### **Planning Commission Staff Report**

**Project Type:** Site Development Plan

**Description:** **The Wedge McGrath Plaza (Energy Express)**: A Site Development Plan, Landscape Plan, Lighting Plan, Architectural Elevations and Architect's Statement of Design for a 5.26 acre tract of land zoned "PC" Planned Commercial District located on the south side of Chesterfield Airport Road west of its intersection with Wings of Hope Boulevard.

**Figure 4: Easternmost access point as approved via Ordinance 2820**

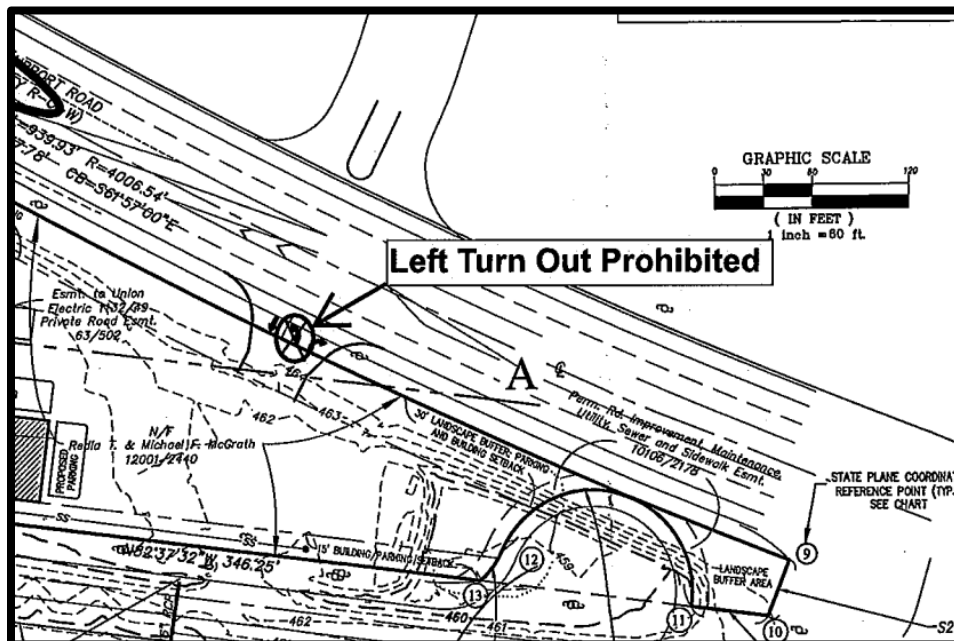
Two access points are provided along Chesterfield Airport Road and two along Old Olive Street Road. However, the configuration of the easternmost access point on Chesterfield Airport Road does not conform to the approved site specific Ordinance 2820 and associated Preliminary Plan. Specifically, the Site Development Plan proposes a left turn movement into the easternmost access of the development which is specifically prohibited, as shown in the following excerpts from Ordinance 2820 and the Preliminary Plan:

The issue of access was discussed at length during the zoning process for this development. Throughout the Site Development Plan review process, Staff has asserted that the access as shown on the Site Development Plan does not comply with the Ordinance; however, the applicant has declined to revise the Plan. The Applicant is requesting approval of the Plan as submitted (see attached letter). Additionally, on August 26, 2016 the City received a letter from St. Louis County stating that they were requiring the left turn movement out of easternmost access to Chesterfield Airport Road. **As City Staff makes our recommendations based upon adherence to the City Code and the planned district ordinance, Staff is recommending that this access be restricted so that no left turn is permitted, as required in Ordinance.**

1. That the easternmost access point comply with Attachment B of Ordinance 2820; and
2. That street lights be provided along Chesterfield Airport Road and Relocated Olive Street Road with a note on the Site Development Plan requiring installation and maintenance be the responsibility of the Developer; and
3. That if the architectural elevations are approved as submitted by the Applicant with the new archways, said archways be reduced in height.

Figure 7: C-Store/fast food building elevation with associated architectural arch element

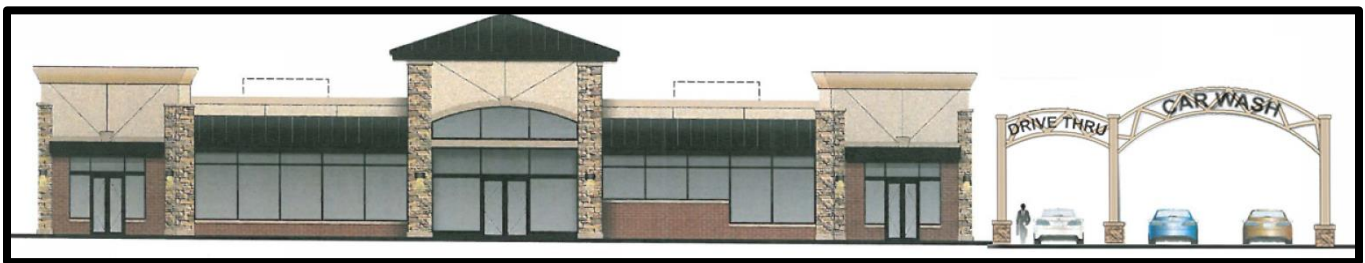
The applicant is proposing to construct an architectural archway feature at the entrance to the car wash and restaurant drive-thru lane entrances adjacent to the c-store building. **This archway, shown in the images below, was not included in the ARB submittal. Based on this, Staff is requesting Planning Commission input of the appropriateness of this feature given its prominent location, size, and visibility from Chesterfield Airport Road.** The proposed archway is 18'6" at the tallest point. Note that although signage is shown, signage is reviewed as a separate process. In this case, the applicant has submitted a Sign Package that is requesting lit signage on the archway. As part of that review, Staff has provided comments pertaining to the prominence and visibility of the signage from Chesterfield Airport Road and will make recommendations pertaining to signage based on the Applicant's response to these comments. Once Staff review of the Sign Package request has concluded, the Sign Package will be placed on a Planning Commission agenda for review.

Regarding the archway as architectural element alone, without consideration to the signage request, Staff would note that it is substantially taller than required to provide the necessary clearance for vehicles to enter the drive thru lanes. Based on this, Staff recommends that the Planning Commission consider reducing the height so it is more integrated with the adjacent building.

**Figure 10: Proposed Architectural Elevation and rendering for ATM**

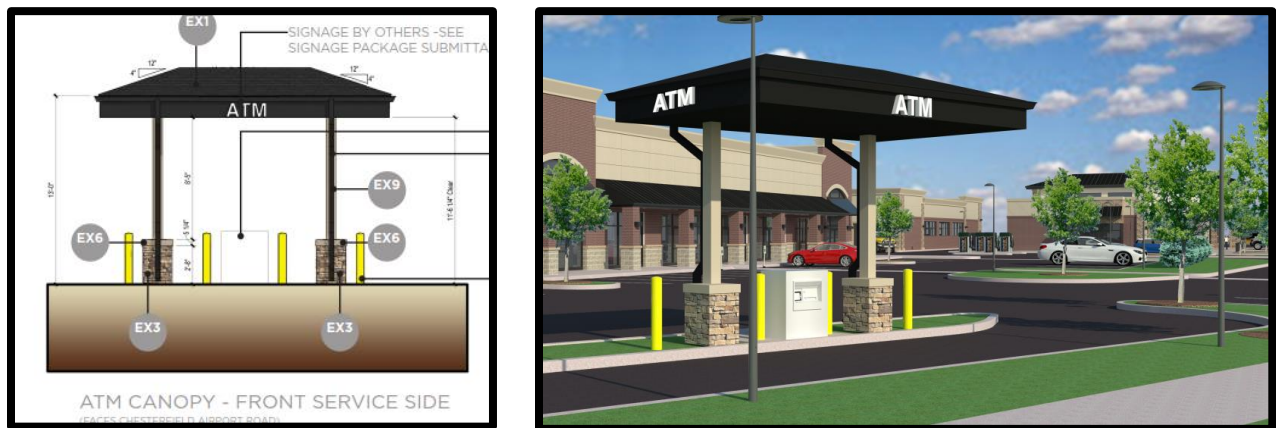
2. *More detail should be provided for the appearance of the ATM area and consideration be made to integrate its design with the proposed architecture of the buildings and/or use landscaping to screen.*

In response to this recommendation, the applicant has provided a rendering and Architectural Elevations for the proposed ATM in order to ensure that the design is integrated with the proposed buildings. Note that the island containing the ATM will be planted with shrubs, as shown in the Landscape Plan.
